This Service Bulletin applies to all Avidyne FlightMax 800 units with the following hardware part number:

Part Number	Rev.
D98-00001-58-G	03

1.3 Reason

It was discovered that on some installations, the latch mechanism was not keeping tension on the unit, allowing it to freely slide out of position. A revised latch mechanism fixes the problem.

3. Accomplishment Instructions

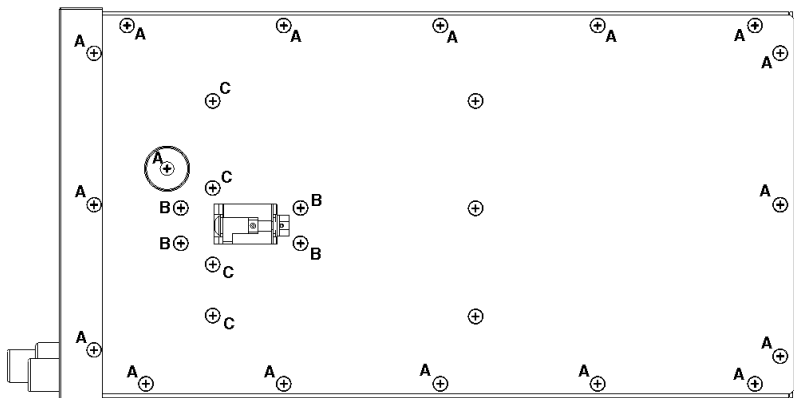
This modification consists of removing the old latch assembly, and replacing it with the new one. This operation is conducted on the bench.

1. Remove the 17 screws marked "A" which secures the lid to the unit.
2. Carefully slide the cover off the unit. Note that a ribbon cable connects a memory device on the lid to the base of the unit.

3. Remove the ribbon cable from the memory device.
4. Remove the 4 screws marked "B" which secures the latch mechanism to the lid.
5. The 4 screws marked "C" may need to be removed to allow the completion of step 6.

6. Position the new latch mechanism in place, and re-secure with 4 screws in the locations marked "B." Torque should be 5.0 – 5.5 in lb. Check that the head of the socket-head screw (part of the latch mechanism assembly) faces the front of the unit (towards the display).

7. Re-connect the ribbon cable to the memory device on the lid.
8. Slide the cover back on the unit, and re-secure with the 17 screws from step one. Torque should be 5.0 – 5.5 in lb. Note that assembly is easiest if the one pan-head screw is assembled first, before the 16 flat-head screws.

9. Insert a 3/32" Allen wrench into the proper hole in the bezel, checking that the latch mechanism turns and slides freely.
